SUBJECT: SOUTH TEXAS PROJECT (STP), UNIT 2 - ISSUANCE OF AMENDMENT
REVISING THE TECHNICAL SPECIFICATIONS TO IMPLEMENT 3-VOLT
ALTERNATE REPAIR CRITERIA FOR STEAM GENERATOR TUBE REPAIR
(TAC NO. MA8271).

Amendment No. 114
License No. NPF-80

ATTACHMENT TO LICENSE AMENDMENT NO. 114

Figure 1 TSP Letter Designations

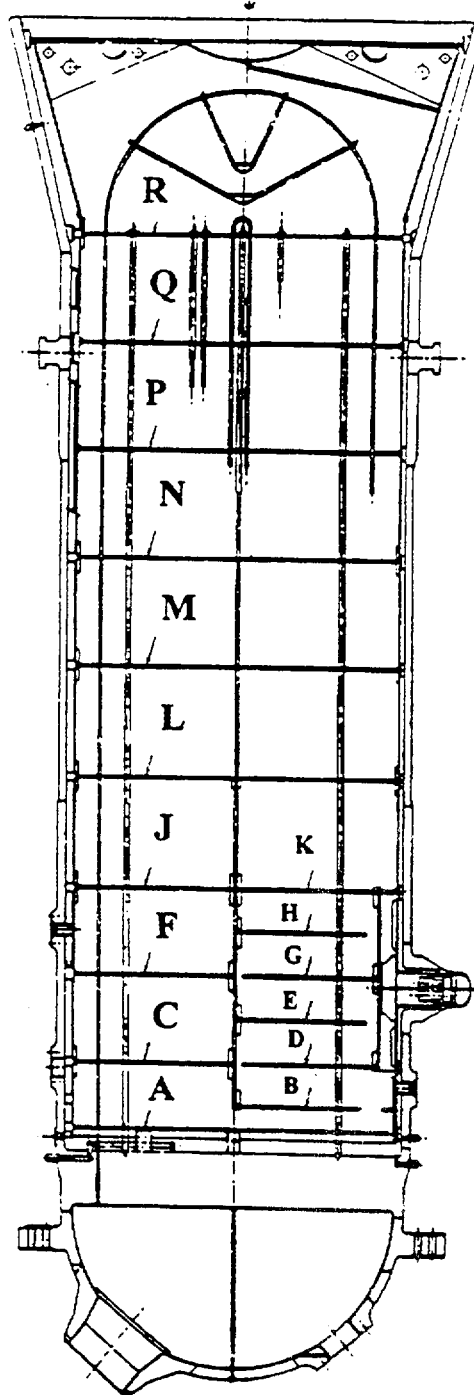
TS 4.4.5.4.a.11 This section is revised to limit the 1-volt ARC to TSPs L through R as identified in Figure 1. This revision is to identify specific TSPs that are covered by the 1-volt ARC as oppose to the TSPs that are covered under the 3-volt ARC.

TS 4.4.5.4.a.11.d) This section is revised to require that the 3-volt ARC are applicable for Unit 2 operating cycle 9 only. It also clarifies that plates C, F, and J as identified in Figure 1 are covered under the 3-volt ARC.
